To: The Effingham Planning Board

March 27, 2022

With Regard to: Meena application for a new gas station

Figure 1. Typical design of a hydrodynamic separator that captures hydrocarbons and sediment from stormwater.

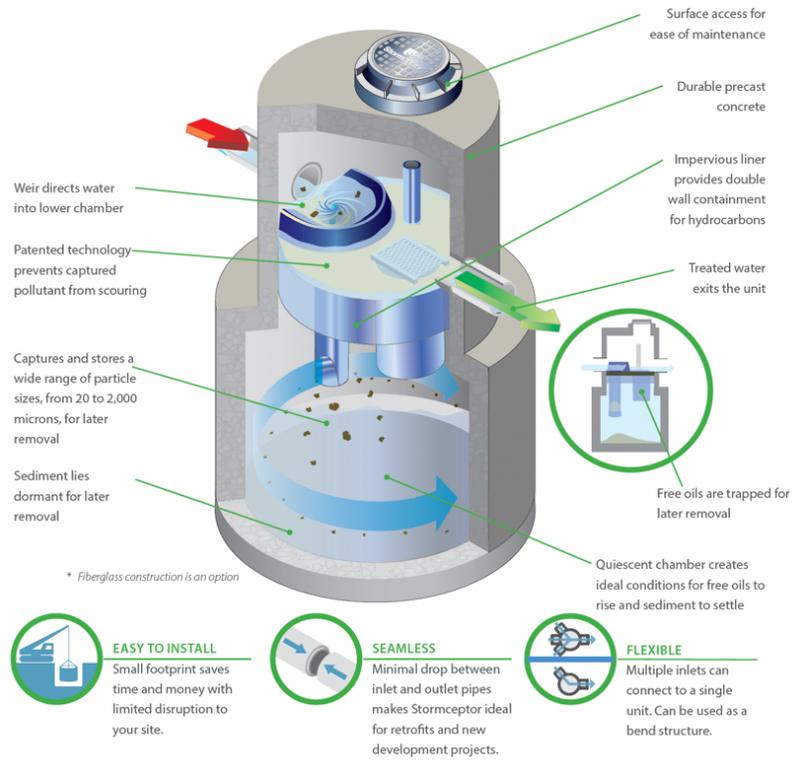
Since the Meena site, located in an old gravel pit, is so vulnerable to contamination, it is absolutely critical that its design conform to the highest level of aquifer protection. The submitted Erosion (sic) and Stormwater Management Plan is completely inadequate and shows a fundamental misunderstanding of the stormwater issues associated with a gas station. The plan to collect untreated stormwater and funnel it into the NH DOT infiltration basin is a recipe for disaster. The floor of the infiltration basin is just above the water table and the lack of a significant unsaturated (vadose) zone minimizes any potential adsorption of contaminants that could occur before entering the groundwater. More importantly it is critical that no water runoff this site without undergoing treatment to remove oil and potentially contaminated sediment. In this hydrogeologic situation all parking lots for any purpose (including gas stations) should be curbed so that all stormwater can be run through a hydrodynamic separator (figure 1) before leaving the site. The hydrodynamic separator collects hydrocarbons and contaminated sediments that are washed off the pavement by the stormwater, preventing them from leaving the site. The curbs serve two purposes, they contain stormwater so that it can be collected and moved through the hydrodynamic separator, and they prevent cars from parking on unpaved areas. Oil and gas leaks from parked cars can be a significant source of groundwater contamination and cars have been parked on unpaved areas at the site in the past (figure 2). The use of curbs coupled with a hydrodynamic separator would ensure that all stormwater would be treated before exiting the site. In addition, an emergency shutoff valve should be installed at the outflow of the separator in order to contain contamination in the event of a major spill. Operation of the valve should be explained in the emergency spill plan. It can be argued, that

at this site, no outflow should be allowed from the stormwater runoff system even with a hydrodynamic separator and that all outflow should be captured and transported from the site.
